BRIDGEPORT ROAD SAFETY AUDIT

ROUTE 1: SHERIDAN STREET TO BRUCE AVENUE

JANUARY 2022

**BOSTON AVENUE (US ROUTE 1)
SHERIDAN ST - PALISADE AVE CONCEPT PLAN**

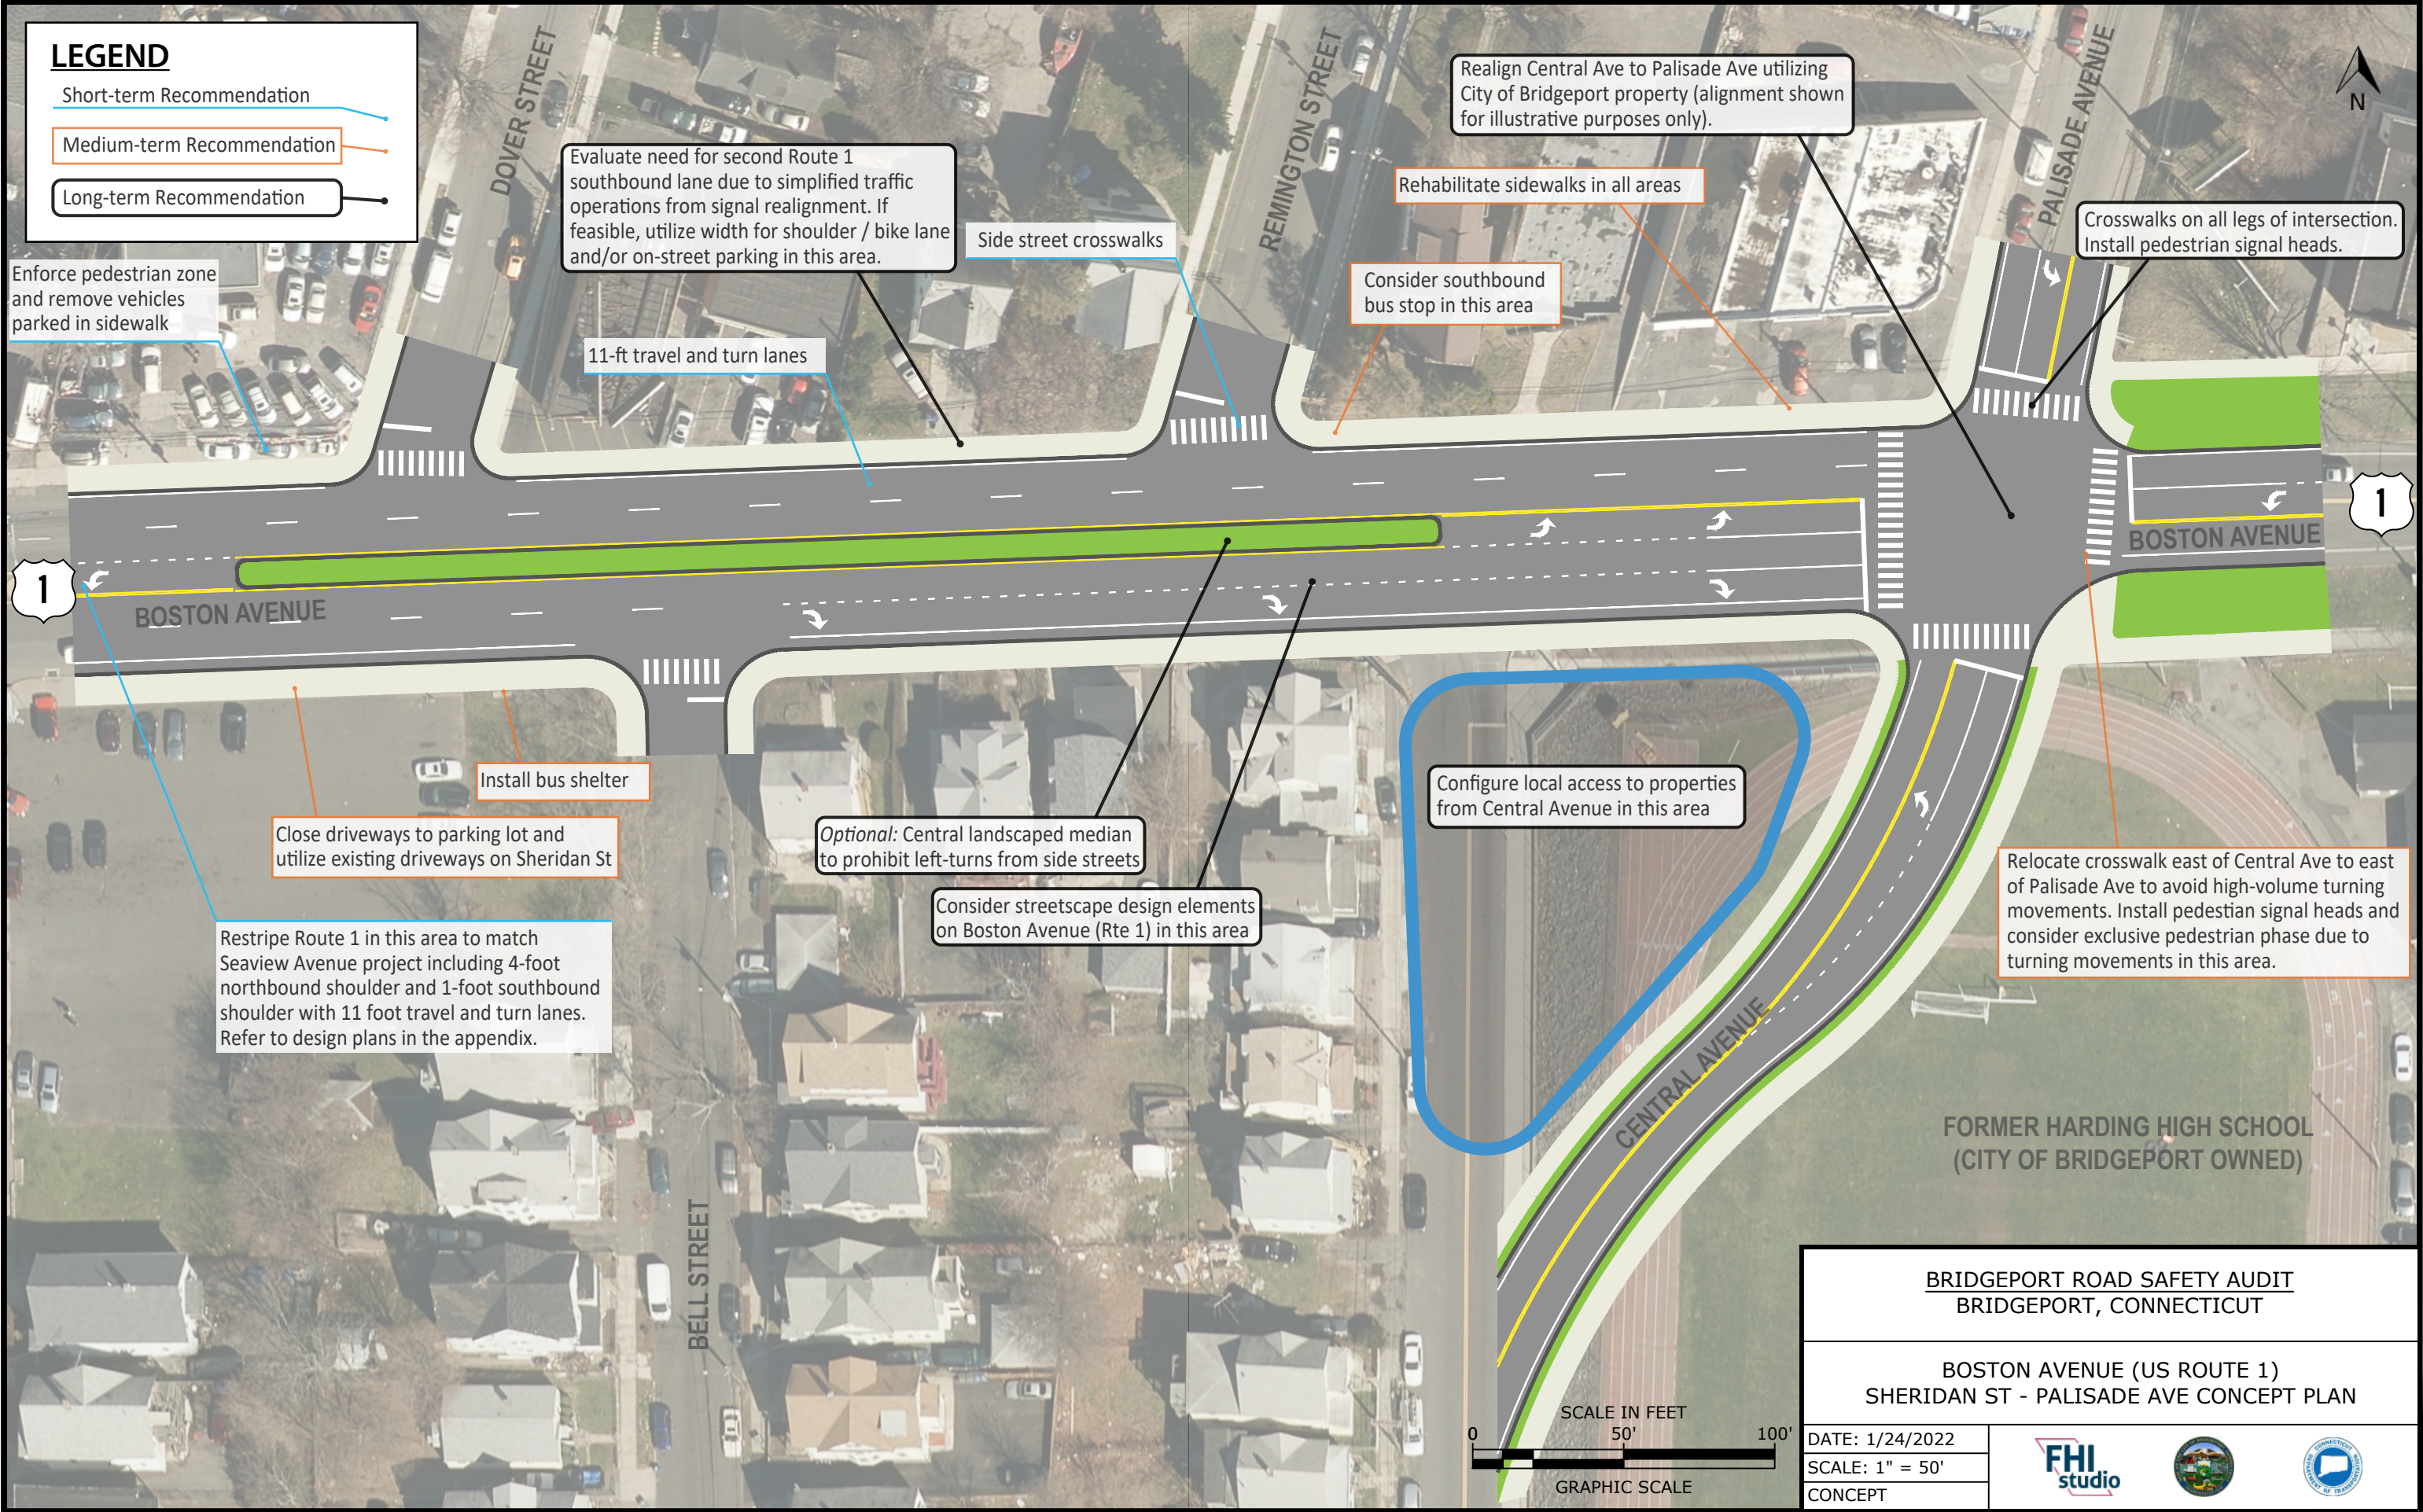
Enforce pedestrian zone and remove vehicles parked in sidewalk

Restripe Route 1 in this area to match Seaview Avenue project including 4-foot northbound shoulder and 1-foot southbound shoulder with 11 foot travel and turn lanes. Refer to design plans in the appendix.

Consider streetscape design elements on Boston Avenue (Rte 1) in this area

Configure local access to properties from Central Avenue in this area

Relocate crosswalk east of Central Ave to east of Palisade Ave to avoid high-volume turning movements. Install pedestrian signal heads and consider exclusive pedestrian phase due to turning movements in this area.
